SUBJECT: NORTH LEAD RAIL IMPROVEMENTS
PROJECT NO. 092938
CONTRACT NO. 070164

ADDENDUM NUMBER FOUR

A. DRAWING R13 – DOUBLE DIAMOND CROSSING (SHEET 68)

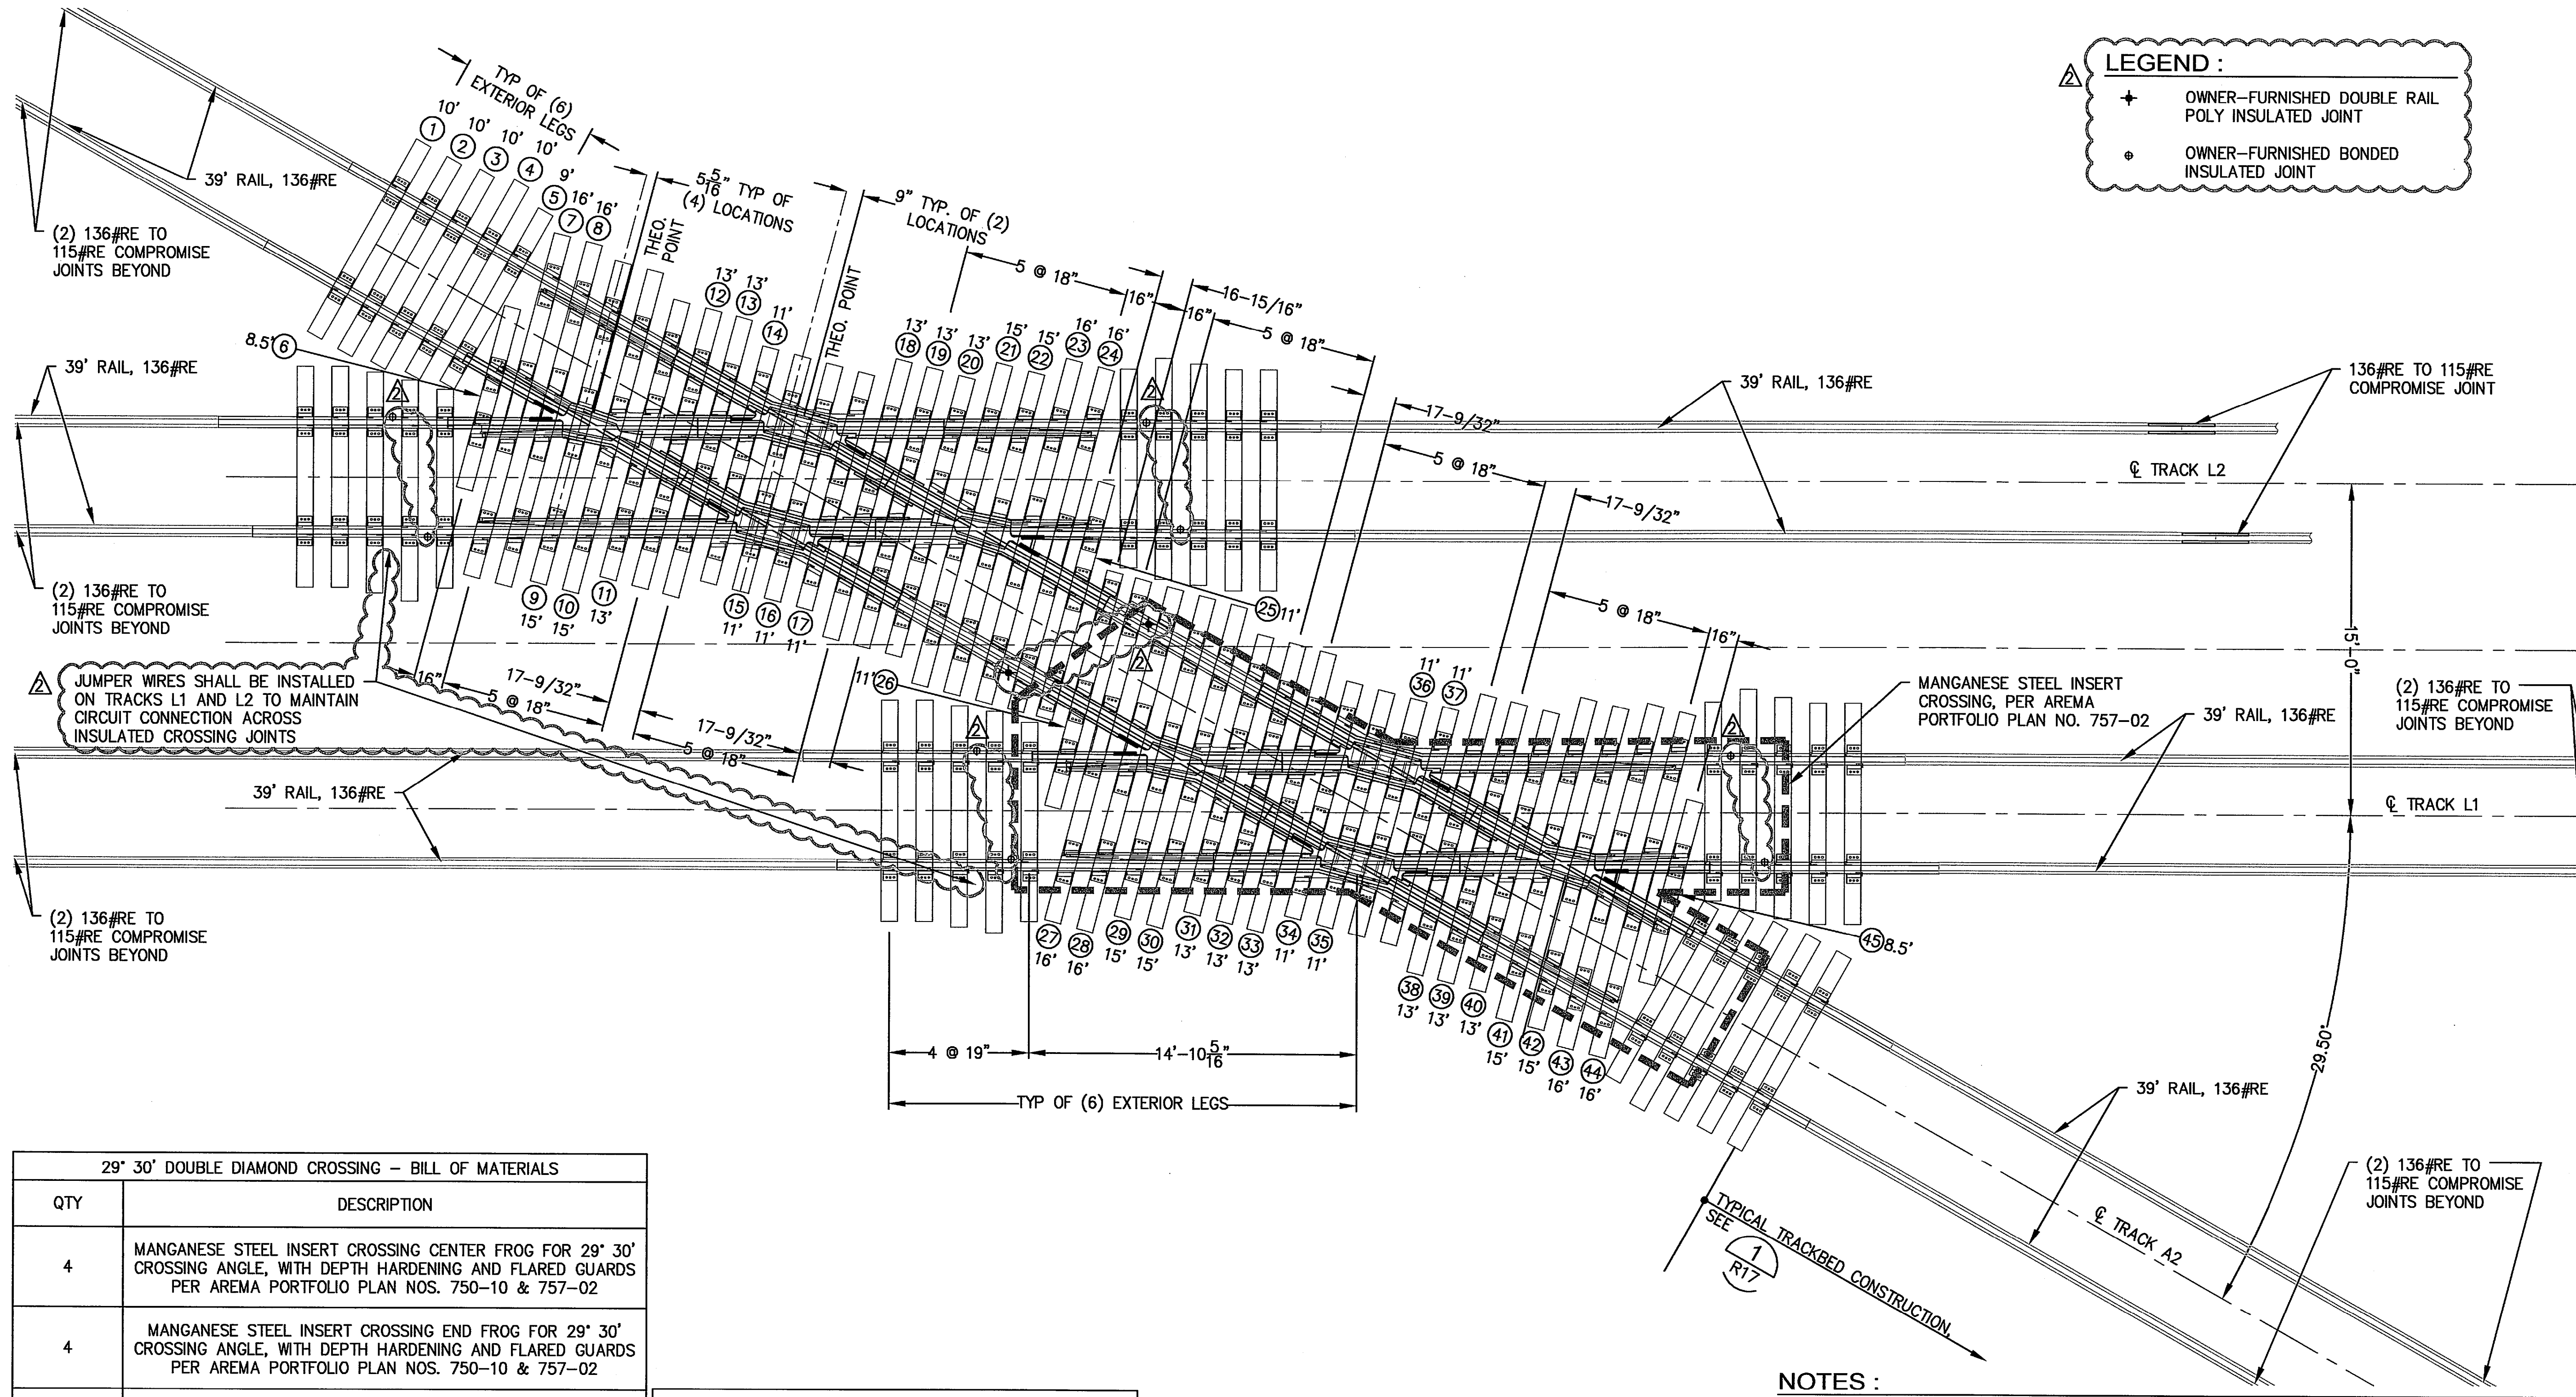
1. **DELETE** and **REPLACE** entire sheet with attached sheet. (Attachment B to this Addendum No. 4)
